E	12/03/12	Section 75W Submission	PL	MD
D	04/11/11	Revised Design following SOPA comments	JC	MD
B	09/09/11	Revised Design following SOPA comments	MD	MD
A	06/04/11	DA Submission	JL	MD
Revision	Date	Description	Initial	Checked

Site 3
Sydney Olympic Park
Plan
Basement 001

Site 3
Sydney Olympic Park
Plan
Level 24

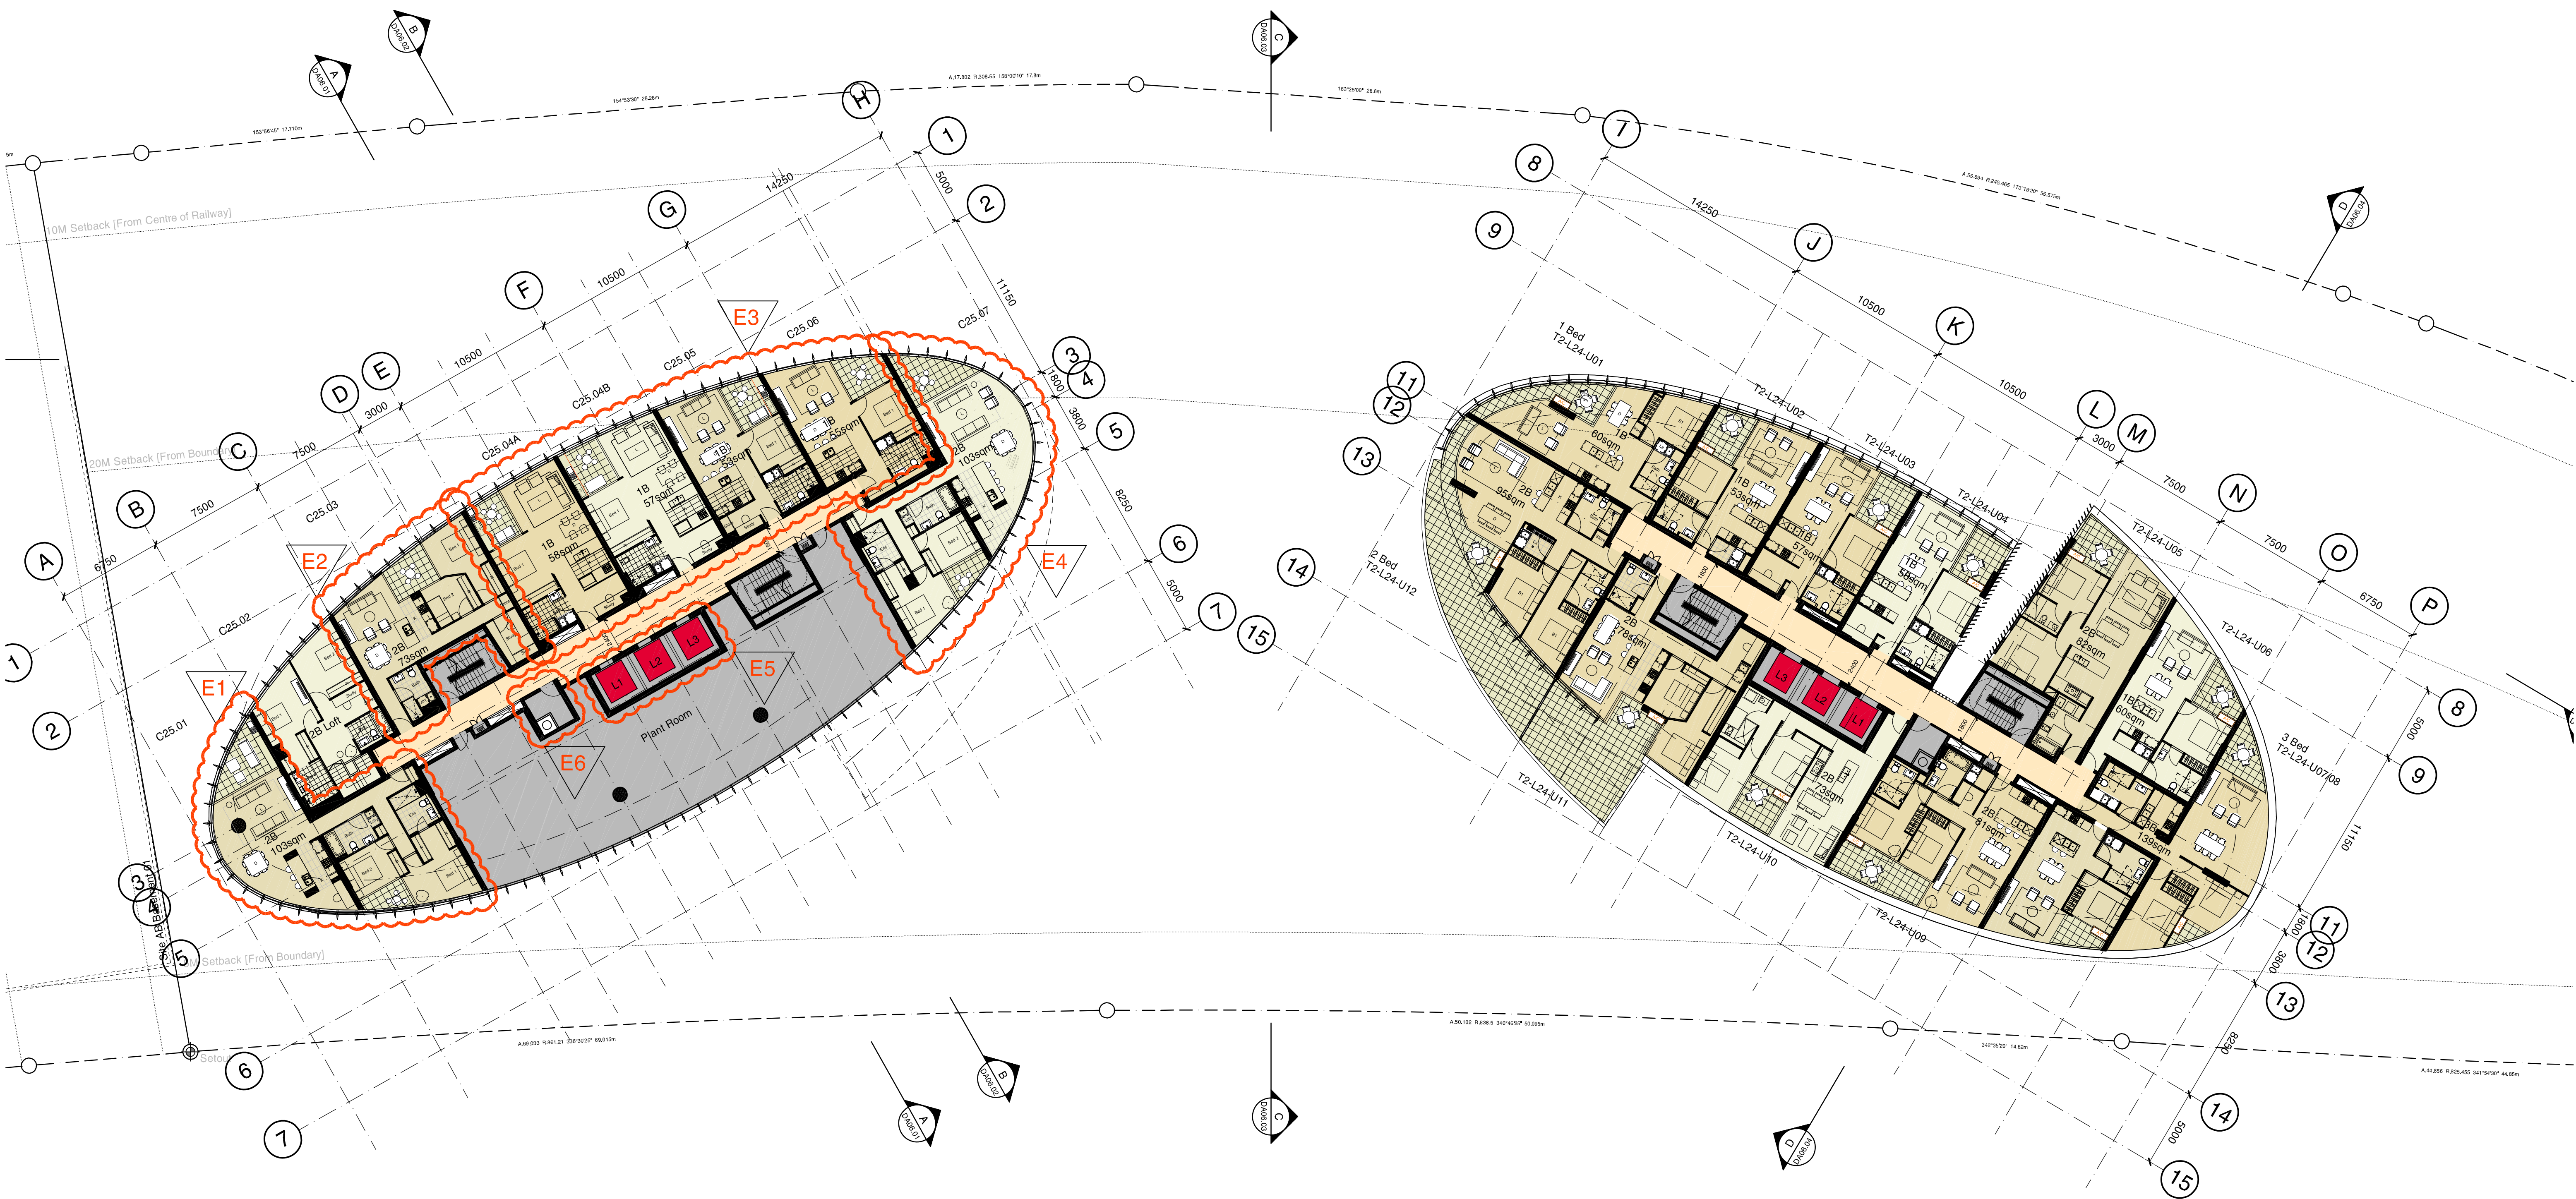
- Revision E - Section 75W Amendments.
- One 3-Bed Loft (C25.01) has been modified to one 2-Bed single storey apartment (C25.01).
 - One 3-Bed Loft (C25.03) has been modified to one 2-Bed single storey apartment (C25.03).
 - One 2-Bed Loft and two 4-Bed Lofts (C25.04, C25.05 & C25.06) have been modified to four 1-Bed single storey apartments (C25.04A, C25.04B, C25.05 & C25.06), including two units allocated as adaptable units.
 - One 3-Bed Loft (C25.07) has been modified to one 2-Bed single storey apartment (C25.07).
 - Lift access has been extended to serve Level 24 apartments.
 - Garage room has been added to serve Level 24 apartments.

Site 3
Sydney Olympic Park
Elevation
North & South

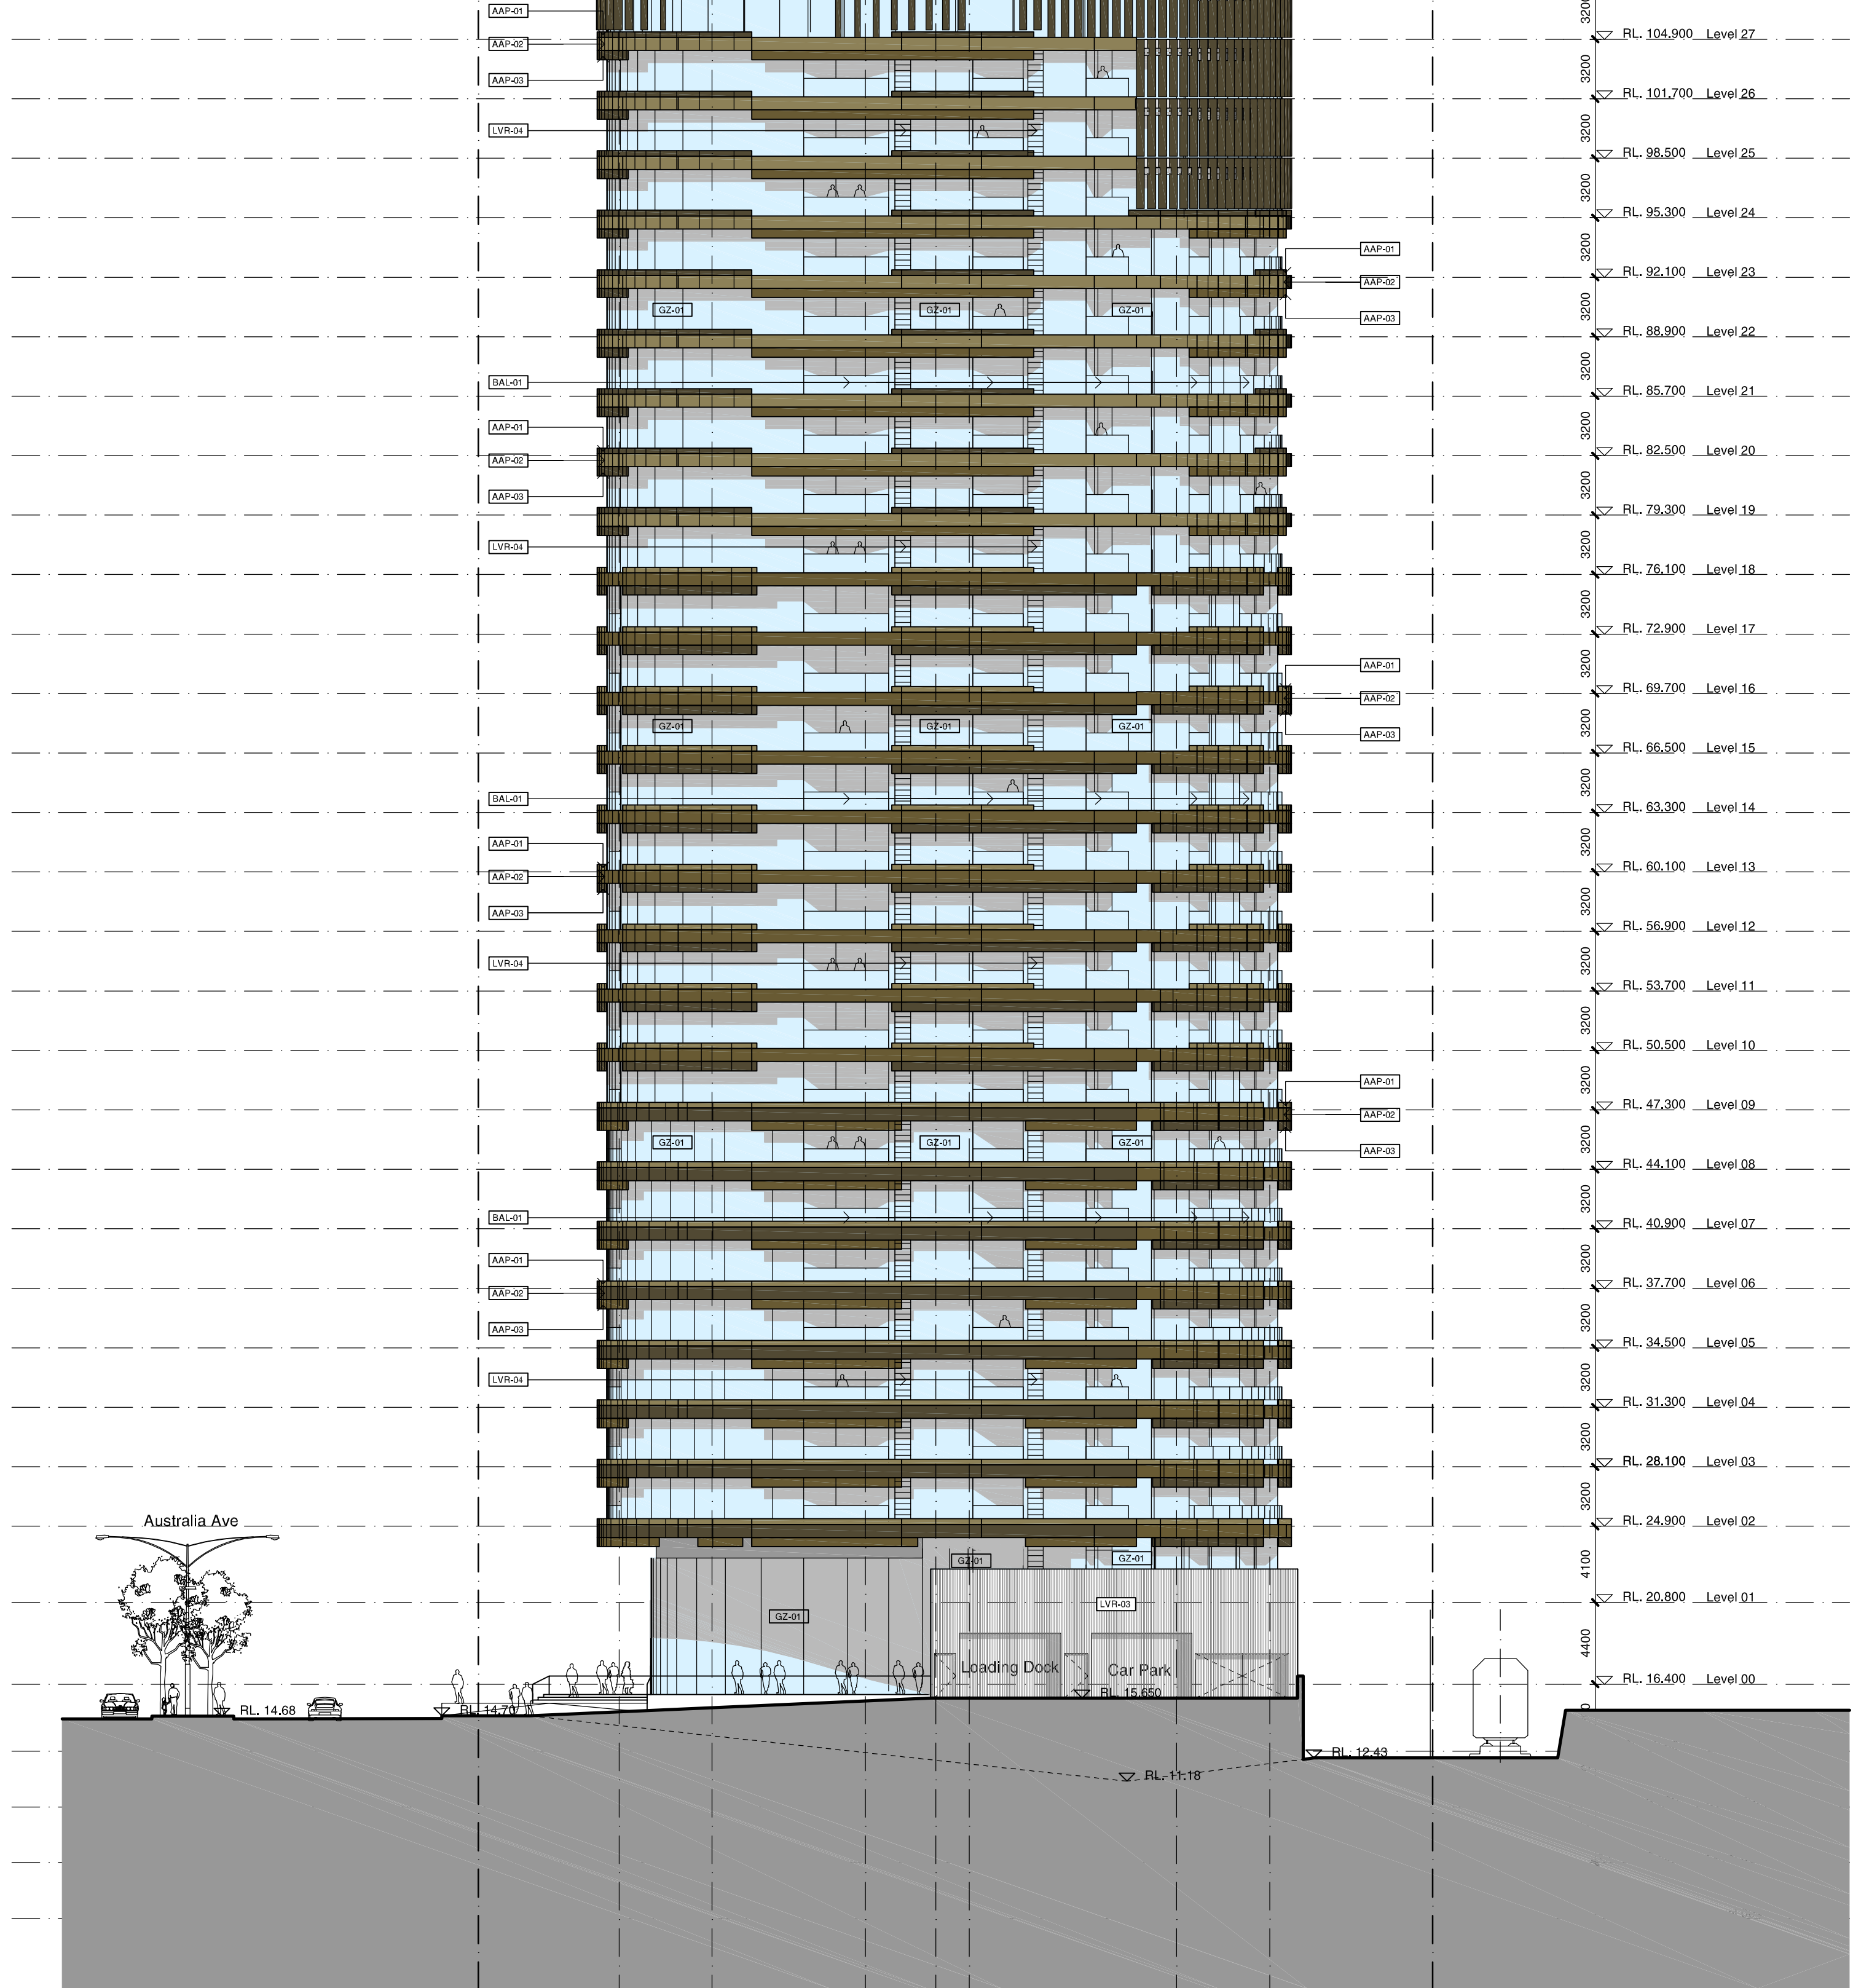
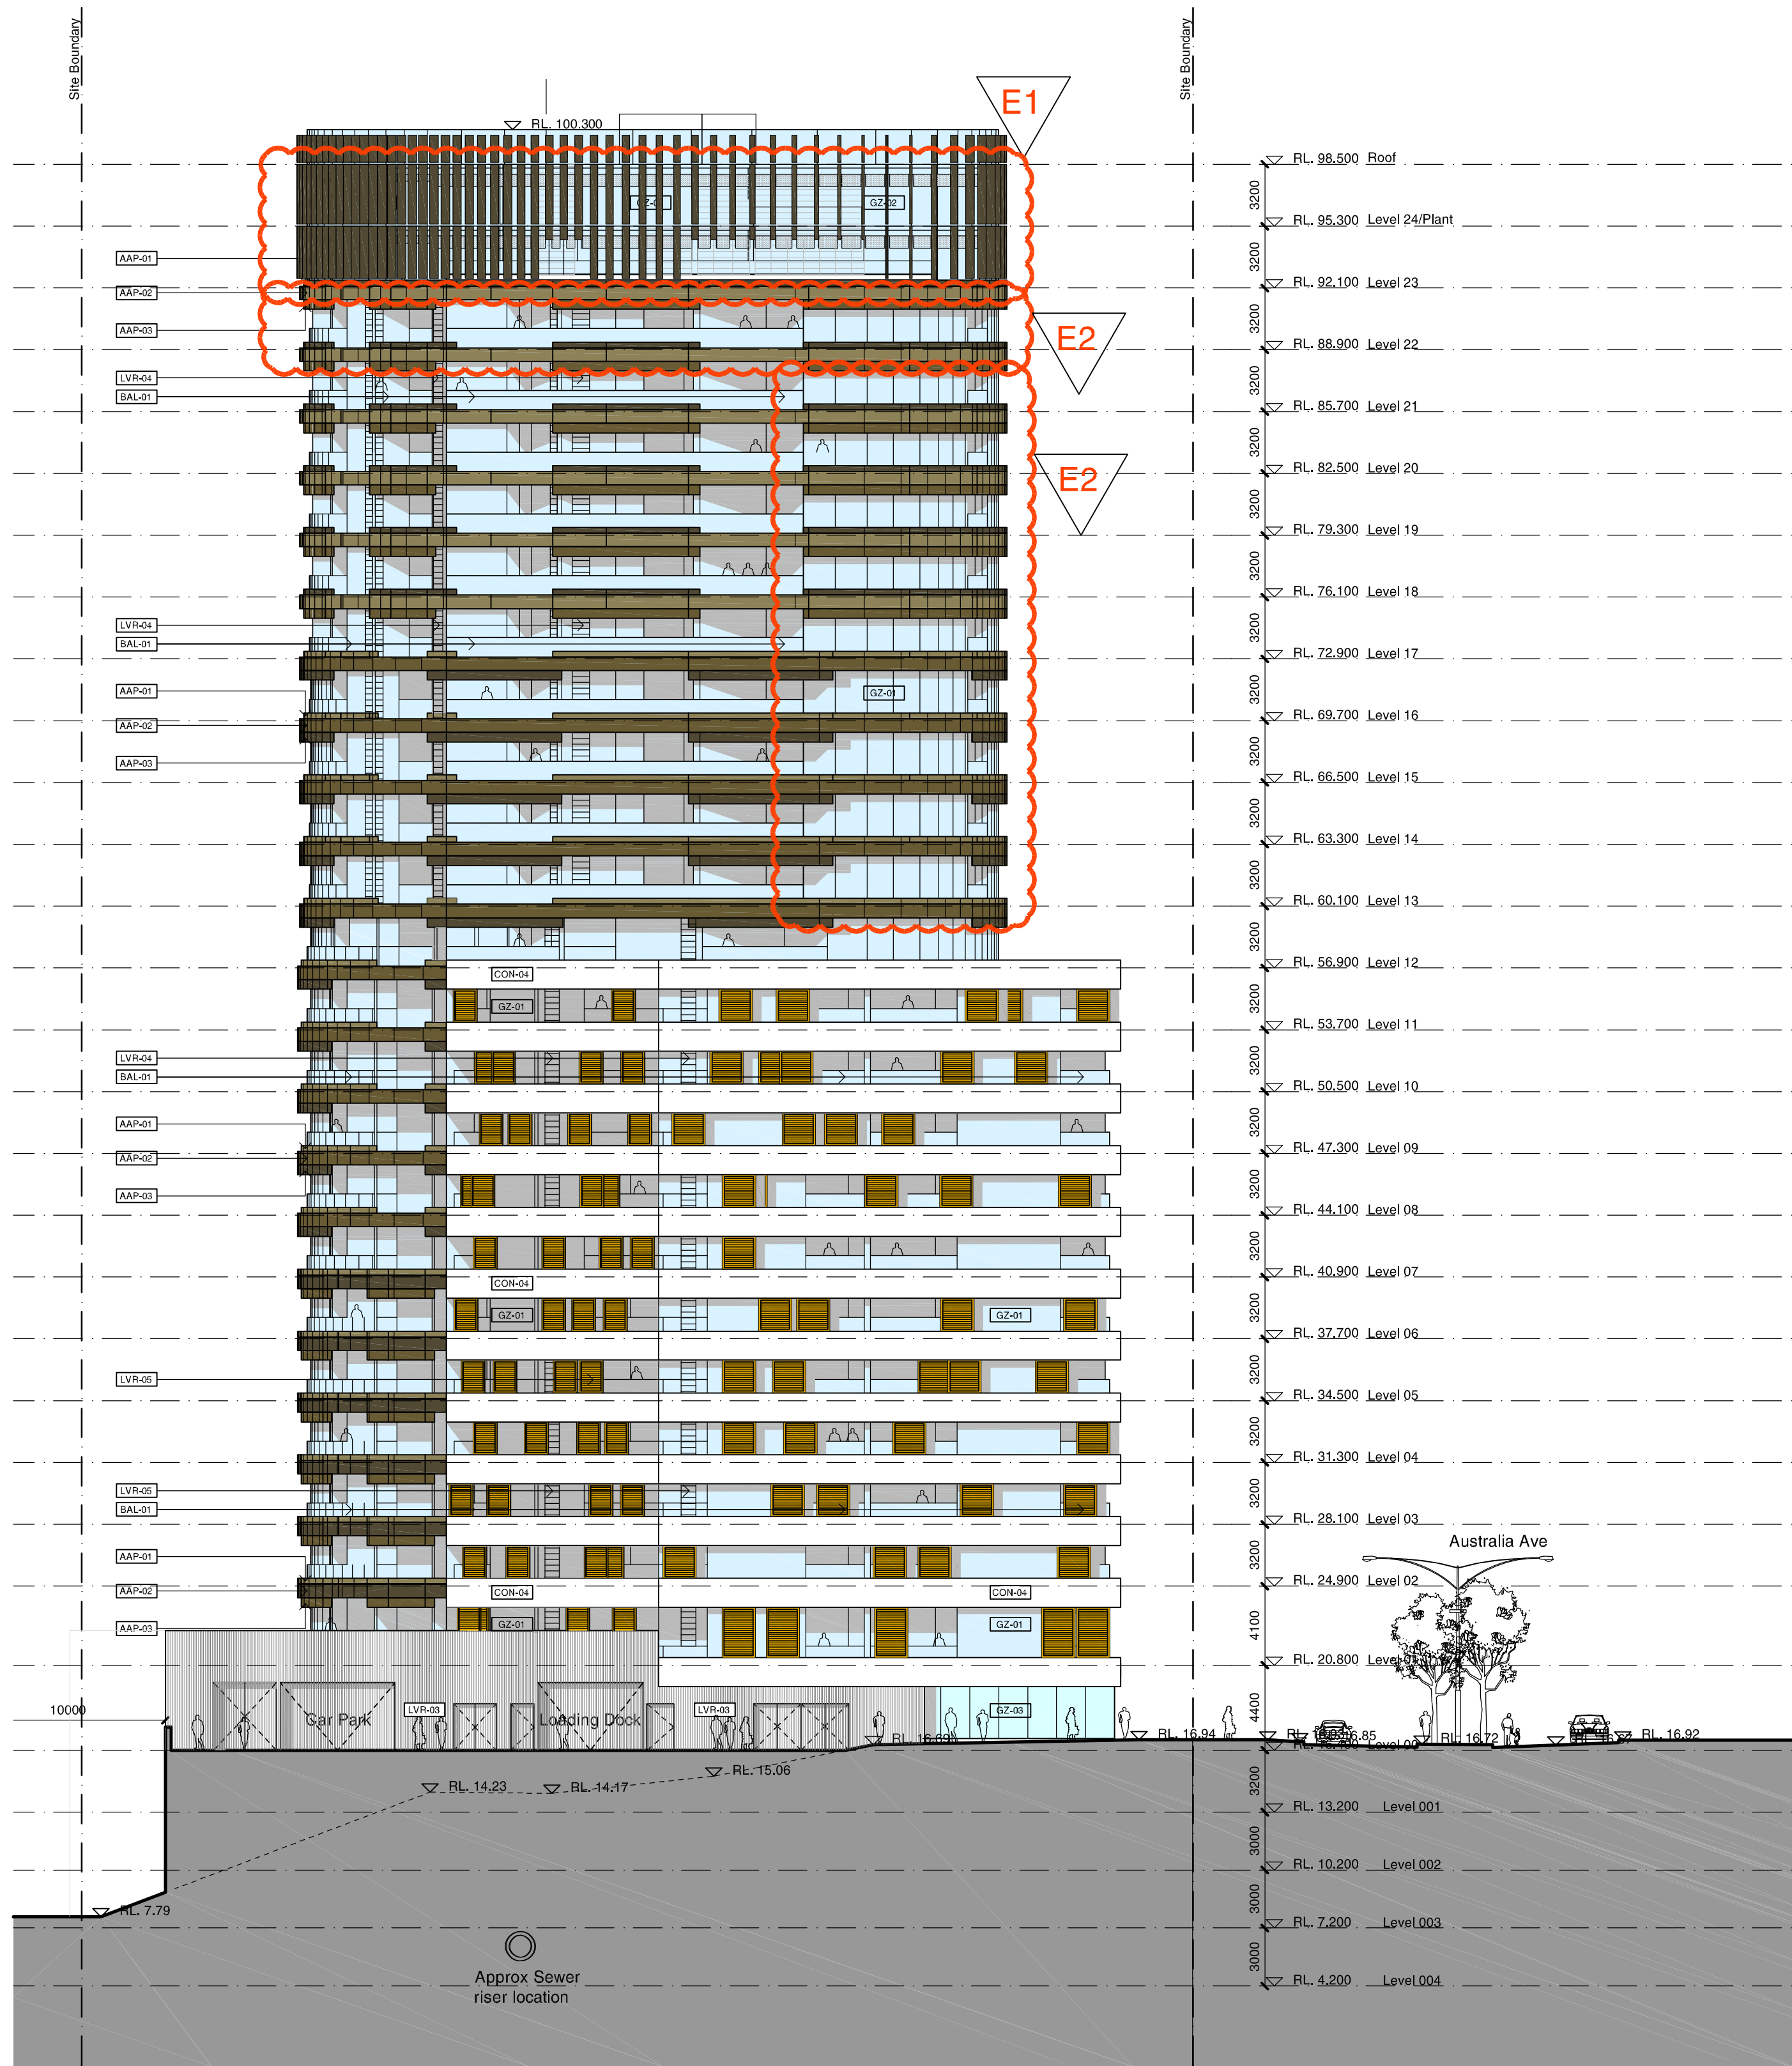
- Loft apartments modified to single storey apartments on Level 23 & 24. Elevation amended to match current plans.
- Elevation amended to match current plans.
